# Addendum I to Environmental Impact Statement

Mr Binman. Ltd. EPA Licence Review  
Application

**Document Title:** Addendum I to Environmental Impact Statement

Figure 11.8

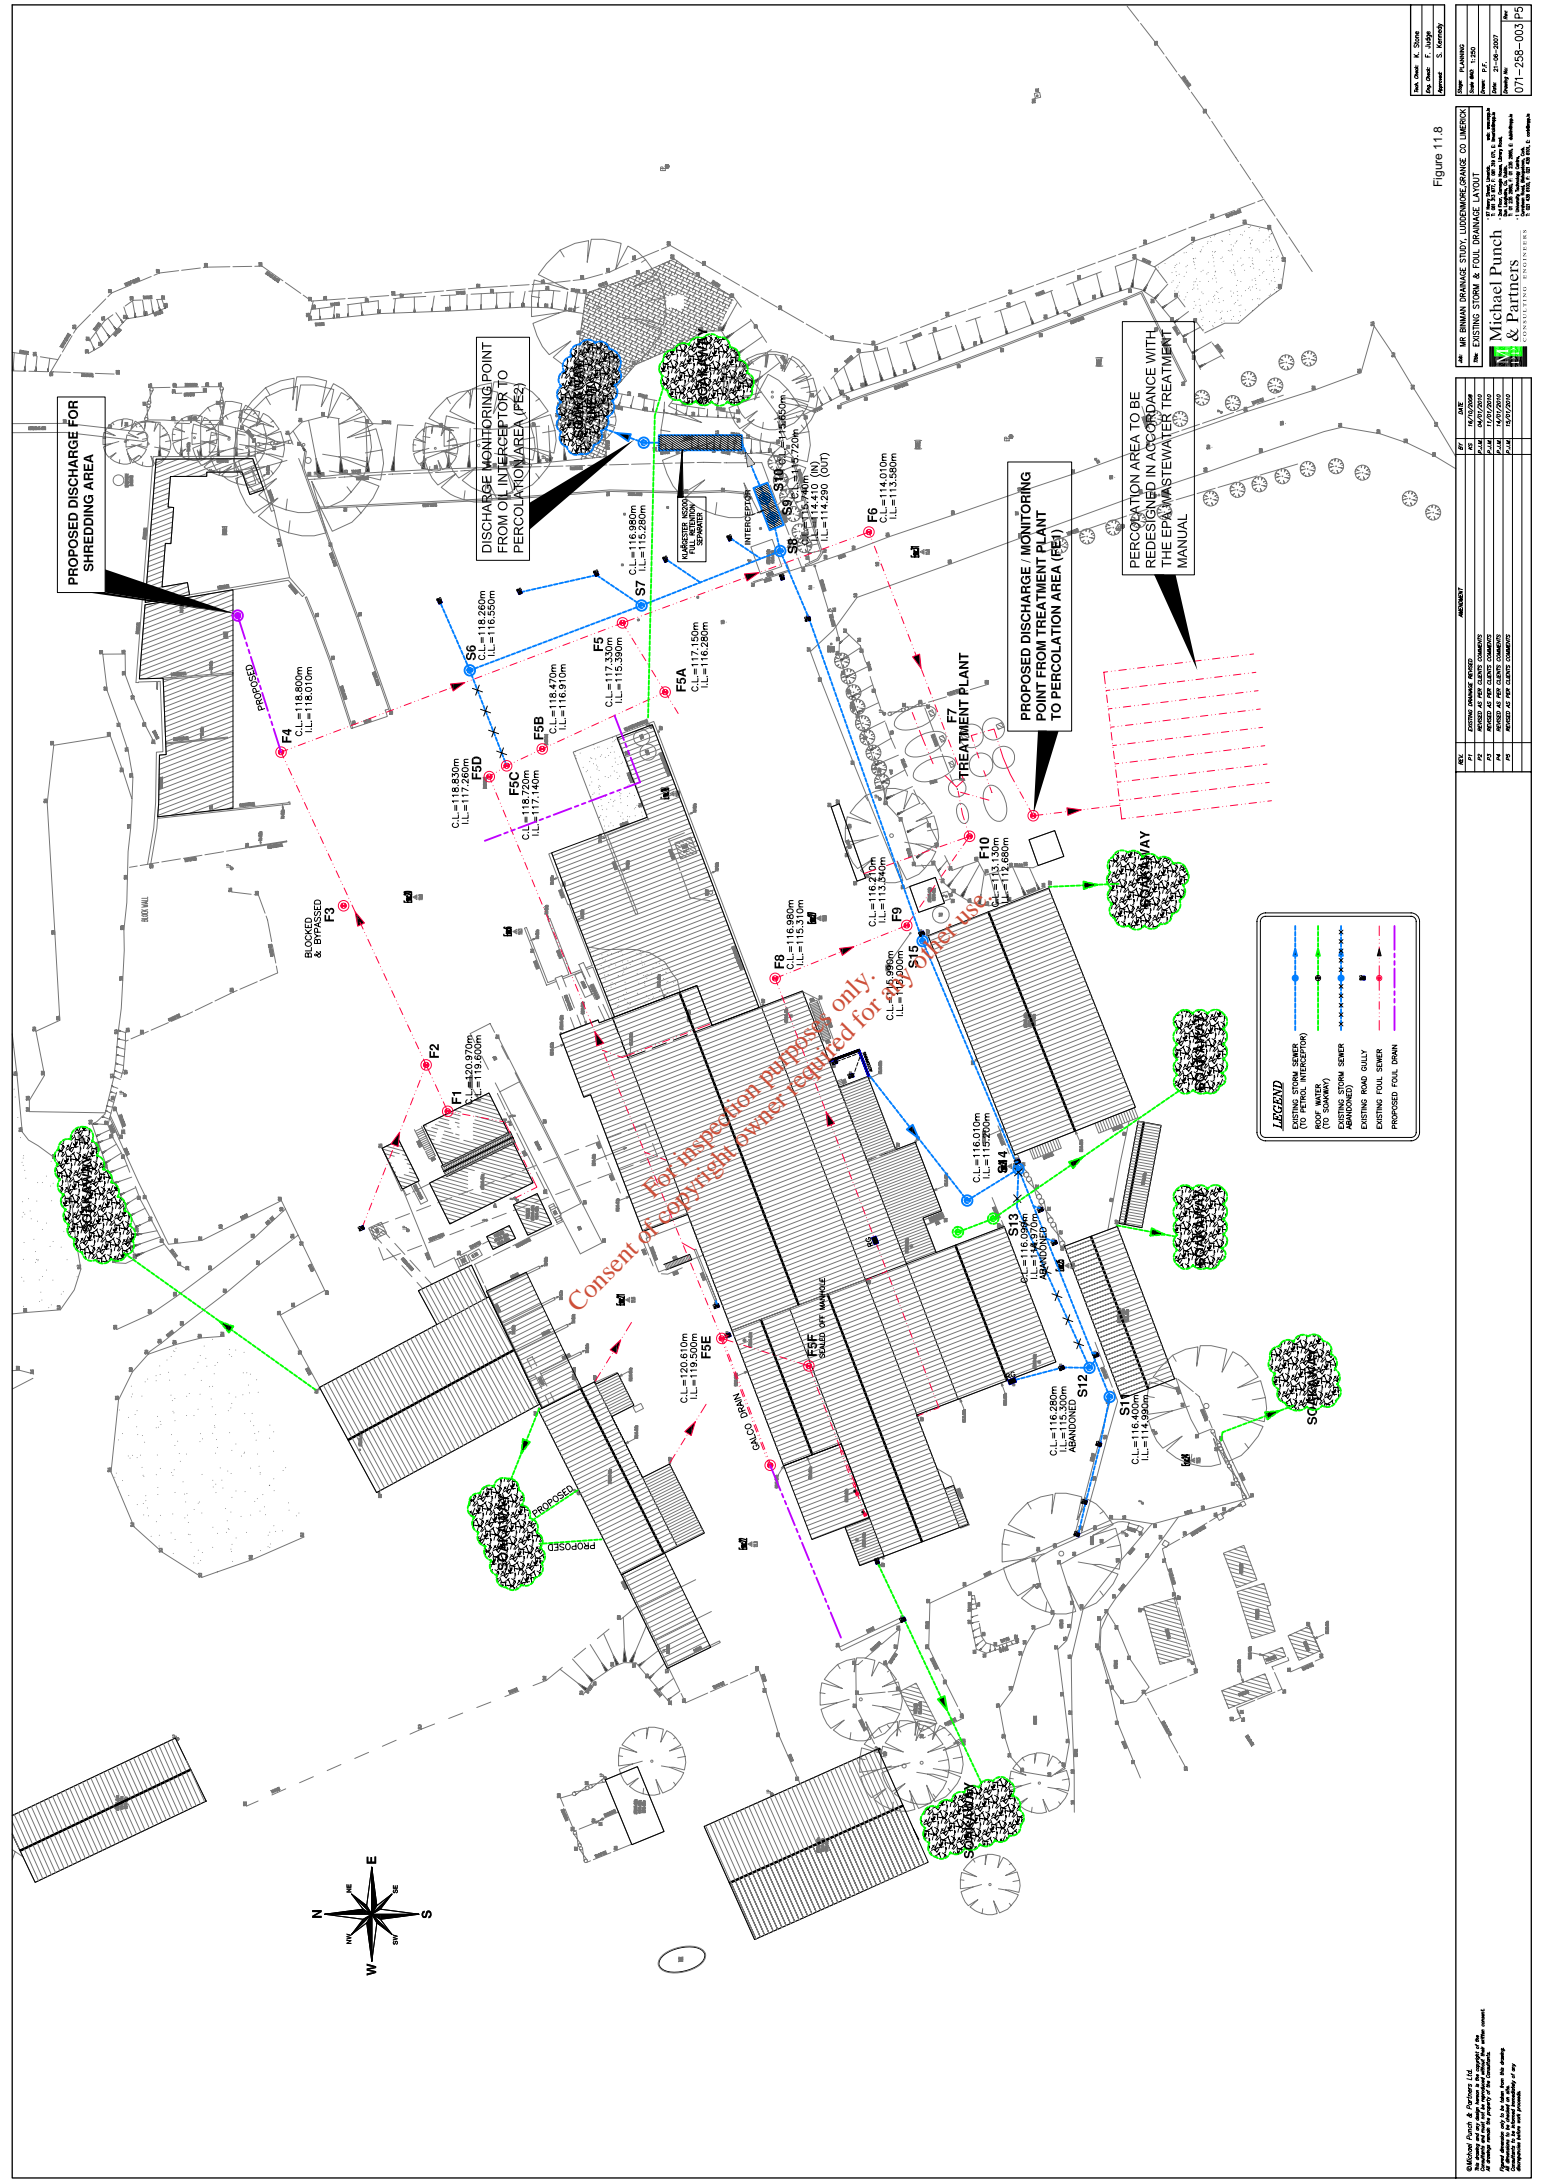
The sections of Chapter 11 of the EIS that have been updated are Section 11.2.2: Surface Water Drainage and 11.2.3: Foul Water Drainage. These sections are set out in Section 11.2: Utility Services. Figure 11.8 has also been updated, and is presented in this document.
